**Before the  
Federal Communications Commission  
Washington, D.C. 20554**

In the Matter of	)	
	)	
Ligado Networks Subsidiary LLC,	)	SAT-MOD-20251206-00374
Debtor-in-Possession: Application	)	S2358
to Modify L-Band Space Station Authority	)	
	)

**REPLY COMMENTS OF THE AEROSPACE AND FLIGHT TEST  
RADIO COORDINATING COUNCIL, INC.**

**Figure 1: Non-Federal AMT Site Locations in the Continental U.S. as of November 2023 (200-mile radius circle shown around each site – potential area of flight test operation)**

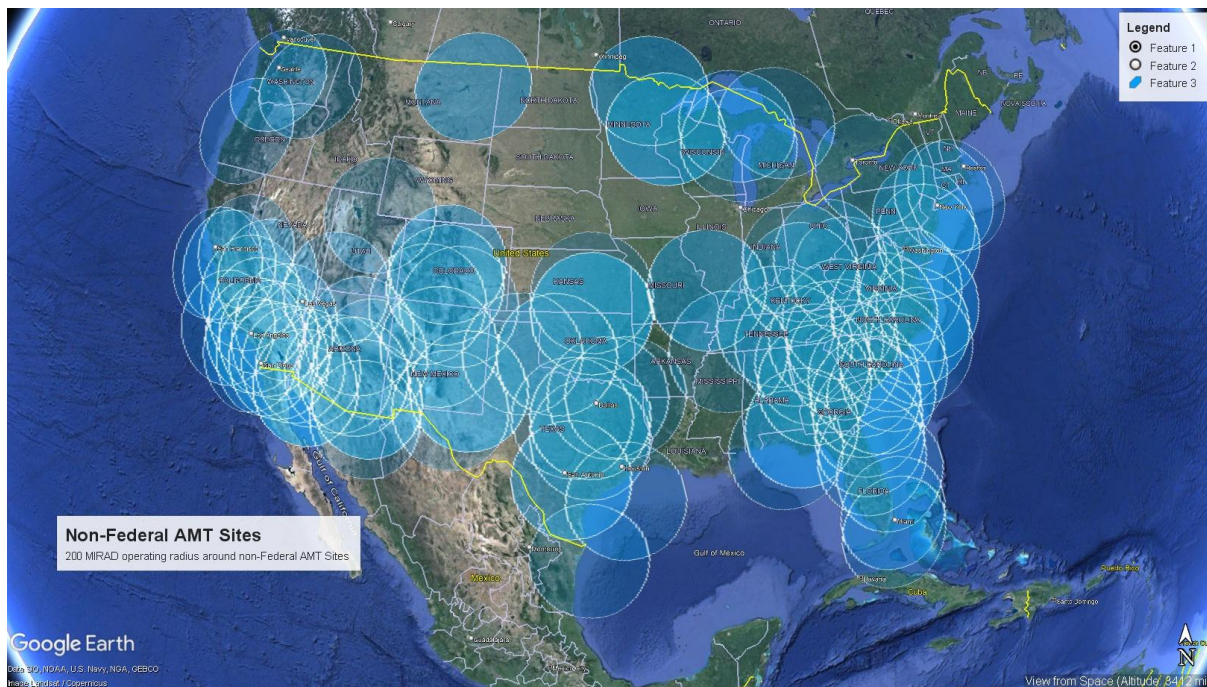
1. The RKF analysis’s description of the spread and distribution of AMT sites, based on a 12-year-old NTIA document describing Federal sites, is very incomplete. Approximately 150 non-Federal AMT sites are located in over thirty states with considerable concentrations in Washington State, Southern California, Arizona, Texas, Kansas, the Southeastern United States, and the mid-Atlantic States. See Figure 1 below. There are even more Federal AMT sites based on the AMT database maintained by AFTRCC. The RKF analysis looks at only a small number of Federal AMT sites, but offers no explanation why or how these sites were chosen for the analysis.
